3/31/09	Added General Note (F)
DATE	REVISION	
STATE OF HAWAII DEPARTMENT OF TRANSPORTATION HIGHWAYS DIVISION BRIDGE GENERAL NOTES INTERSTATE ROUTE H-1 EXTENSION AND REPAIR OF SCHOOL STREET ON-RAMP RETAINING WALL Project No. H11-01-08 Scale: As Noted Date: Feb., 2009

3/31/09	Revised and/or Added Callouts and Legend
DATE	REVISION
STATE OF HAWAII DEPARTMENT OF TRANSPORTATION HIGHWAYS DIVISION RETAINING WALL REPAIR and EXTENSION EXISTING SITE PLAN INTERSTATE ROUTE H-1 EXTENSION and REPAIR of SCHOOL STREET ON-RAMP RETAINING WALL Project No. H11-01-08	
Scale: As Noted	Date: Feb, 2009
SHEET No. Q3 OF 34 SHEETS

RETAINING WALL REPAIR and EXTENSION

SECTION Scale: 3/4"=1'-0"

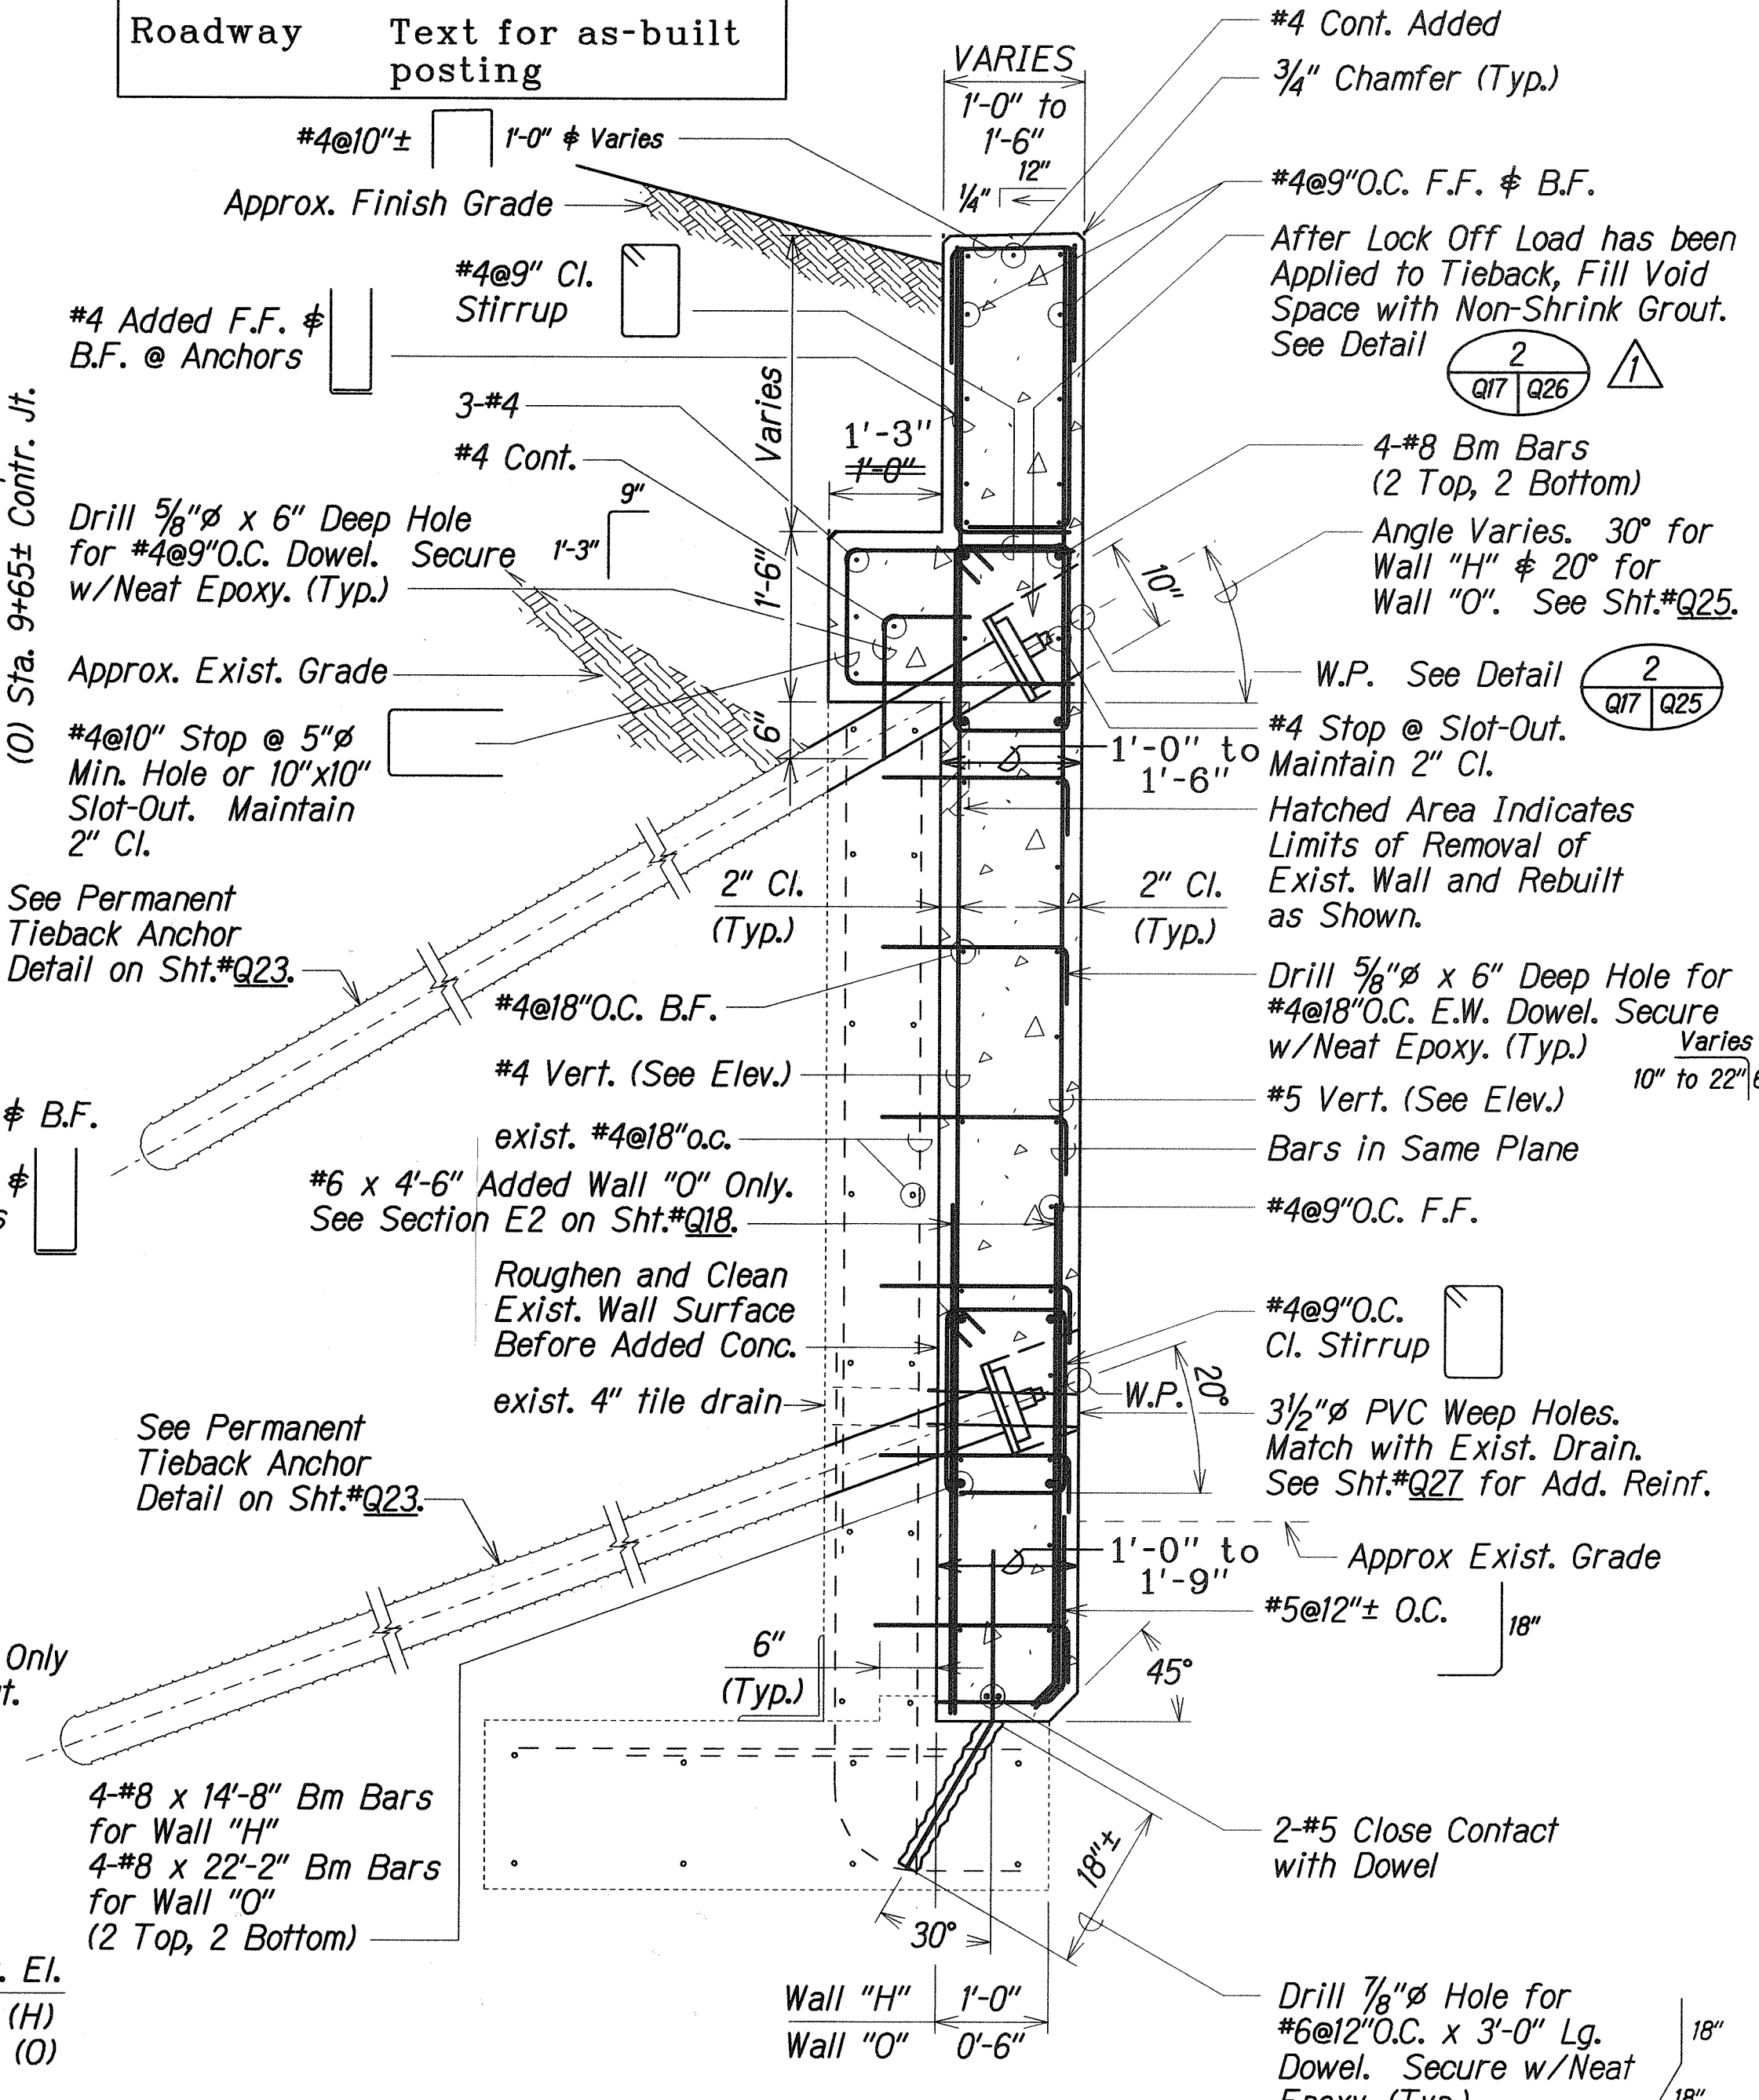
DATE	REVISION
3/31/09	Revised Detail Designation

Scale: As Noted Date: Feb. 2009
SHEET No. Q19 OF 34 SHEETS

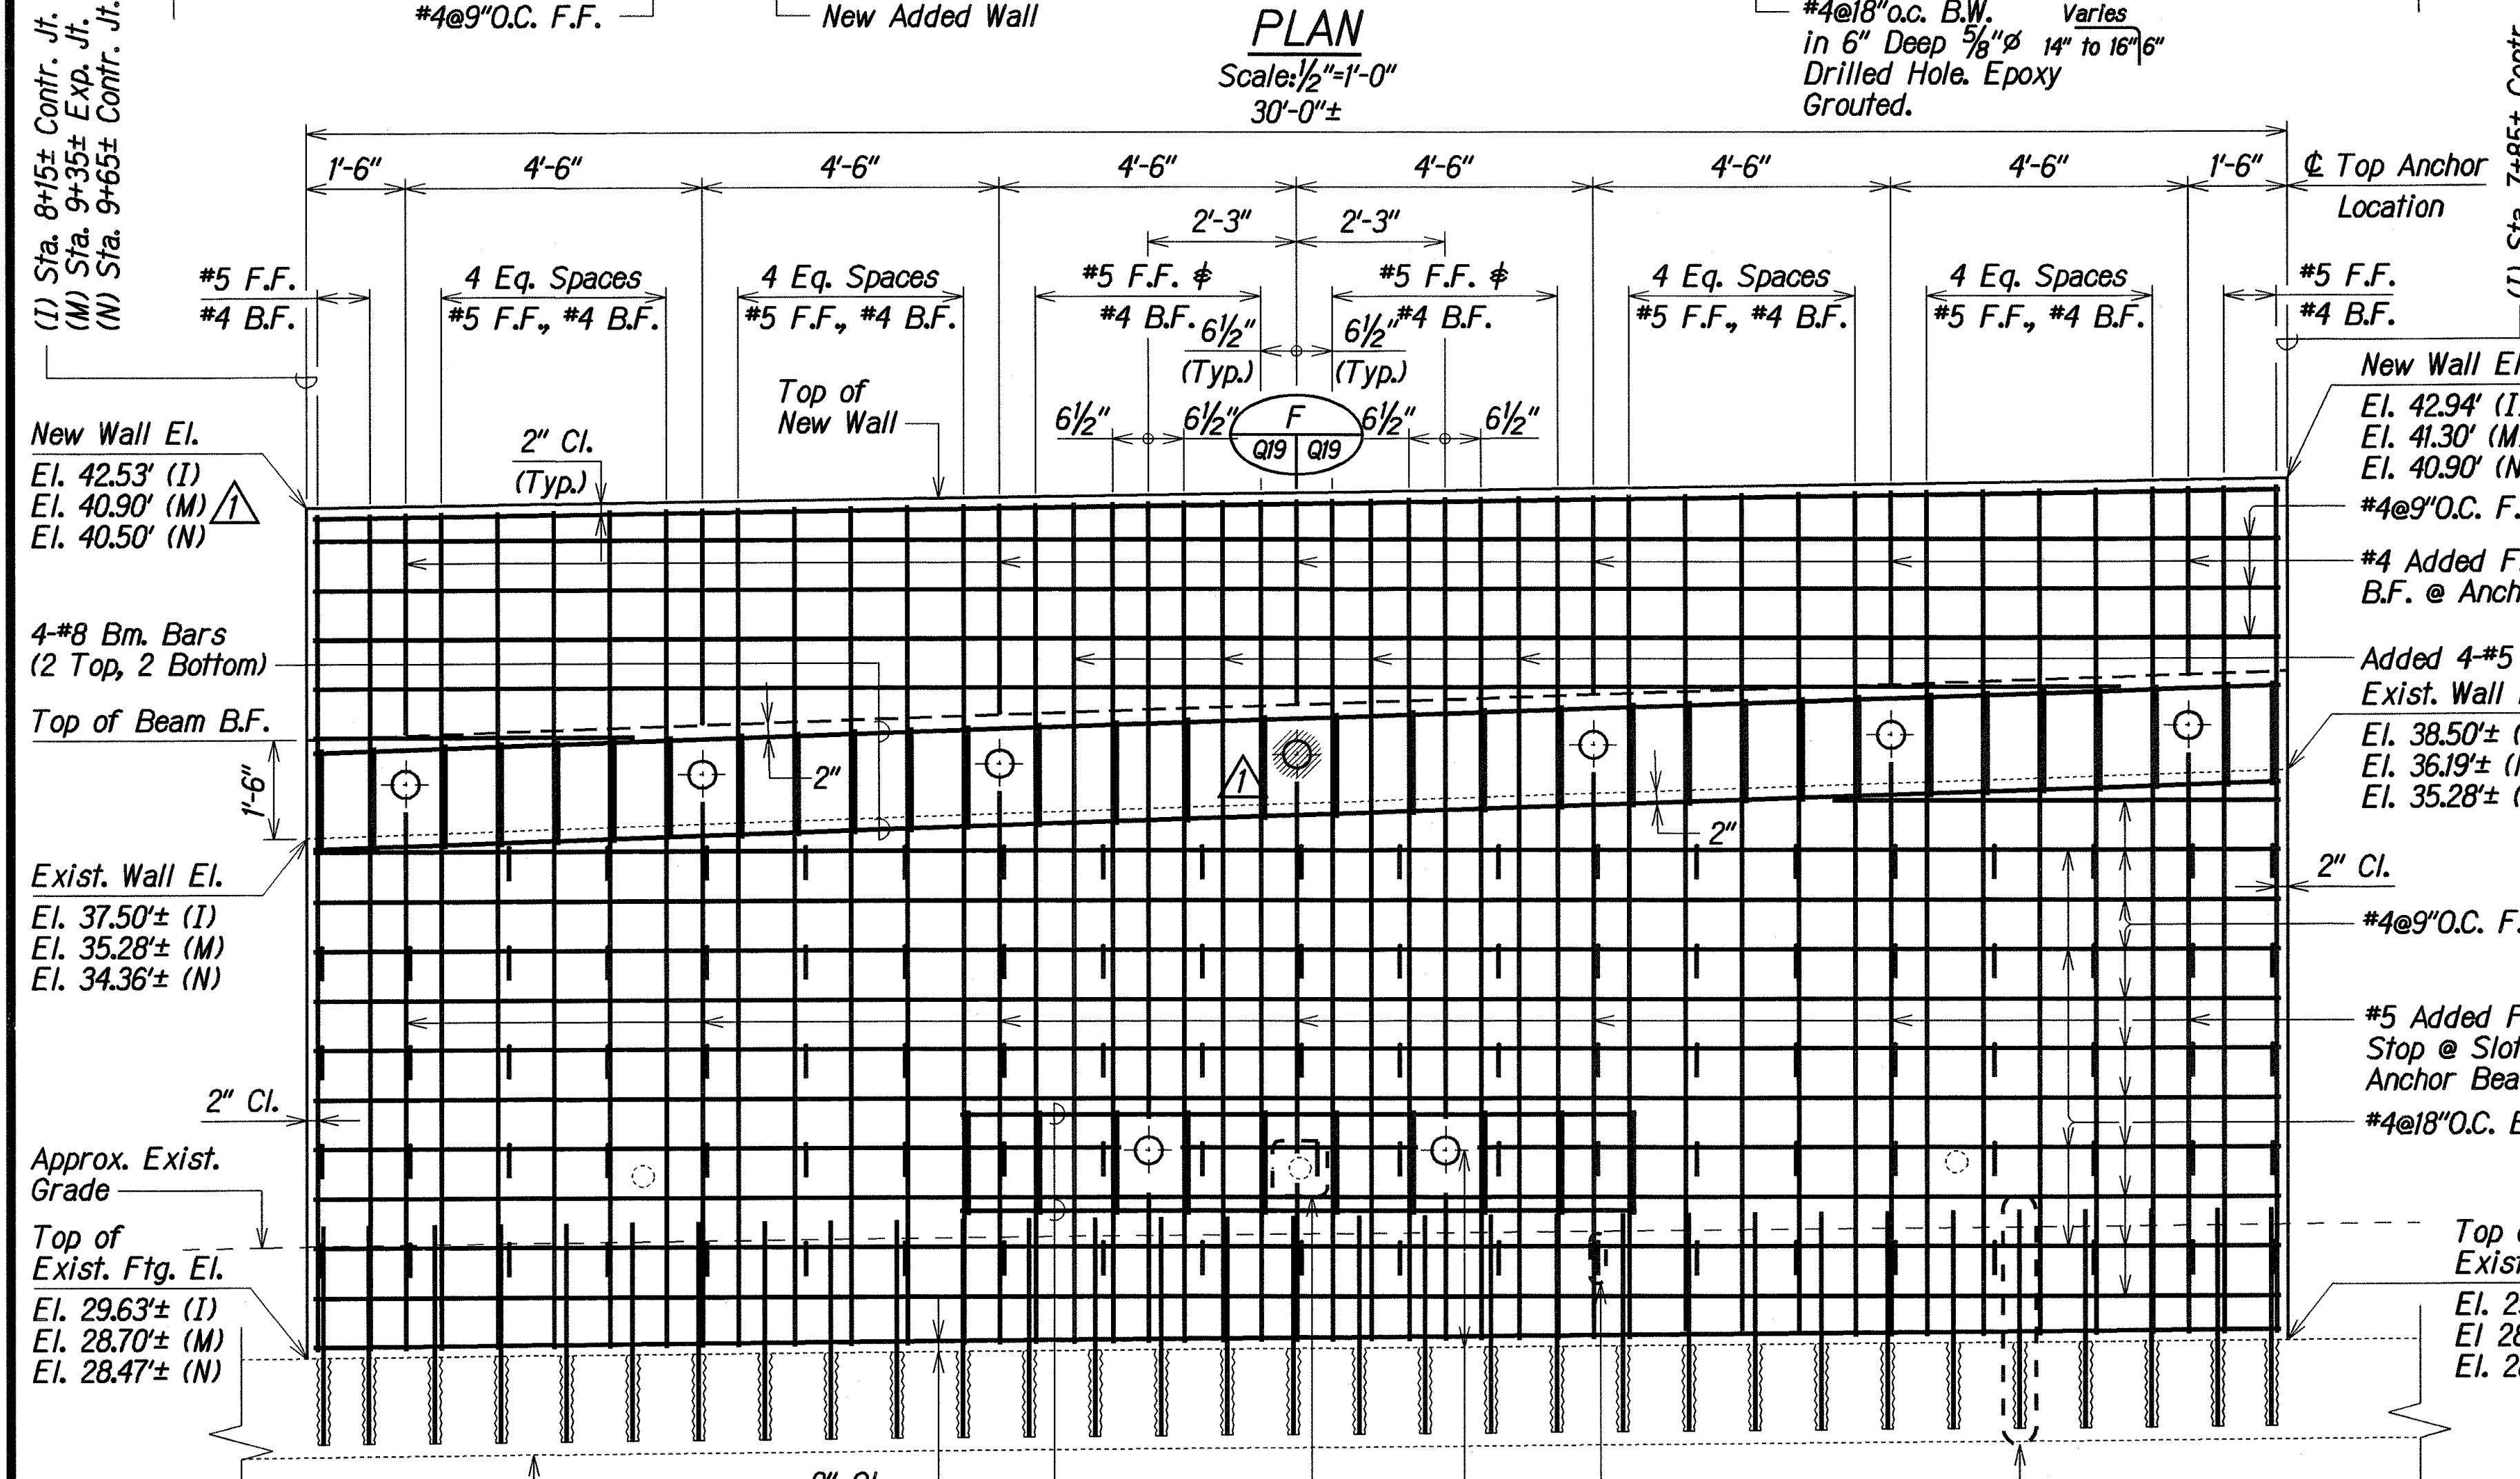
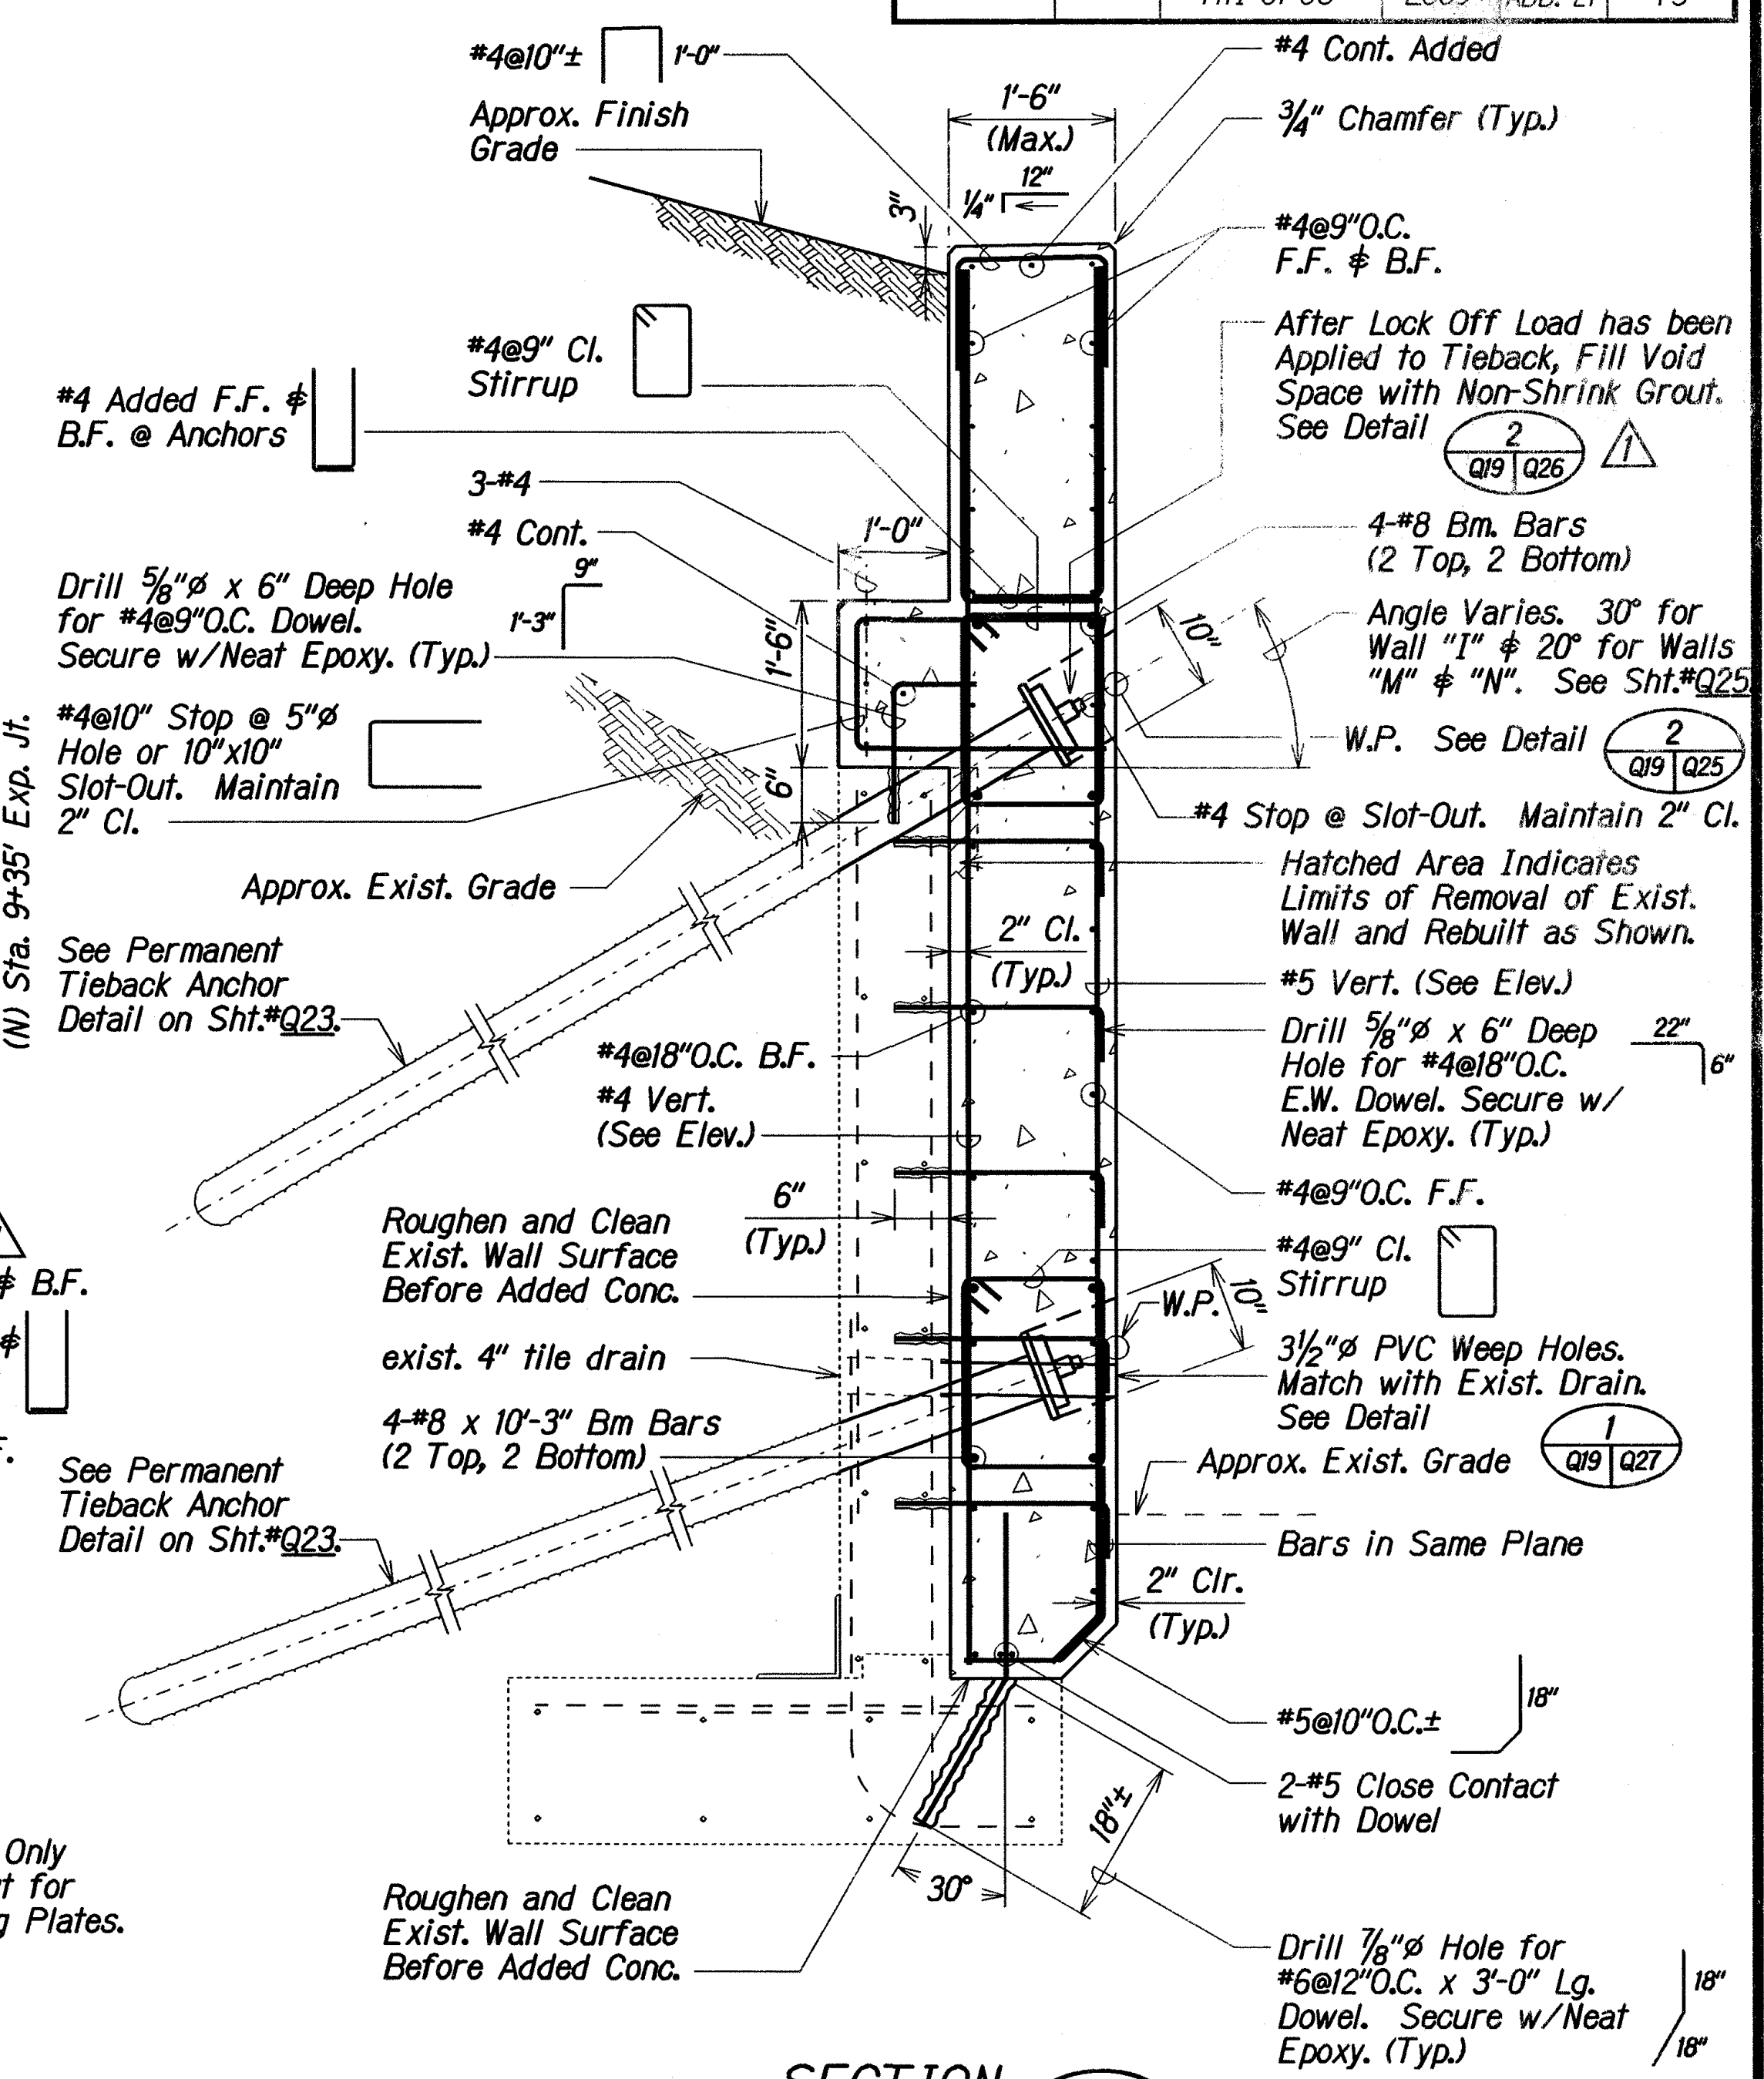
DATE	REVISION
3/31/09	Revised New Wall Elevations (M) & (N), Revised Detail Designation and Hatched Proof Test Anchor
